Engineering Change Notification

NHD-2.4-240320CF-CSXN#
NHD-2.4-240320CF-CSXN#-F
NHD-2.4-240320CF-CSXN#-FT
NHD-2.4-240320CF-CSXN#-FR
NHD-2.4-240320CF-CSXN#-FTR

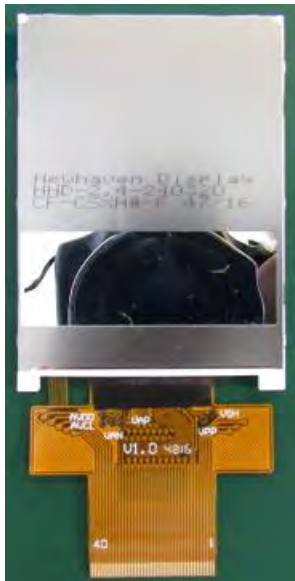
The metal backing on these displays has been redesigned to eliminate the opening in the bottom half of the display.

This design change was made to enclose the entire back of the display, covering the exposed backlight reflector which was previously susceptible to damage from external factors.

This change should not have any effect on the form, fit or functionality of the display in your application. We understand that each project is unique and therefore recommend you to evaluate new samples for validation.
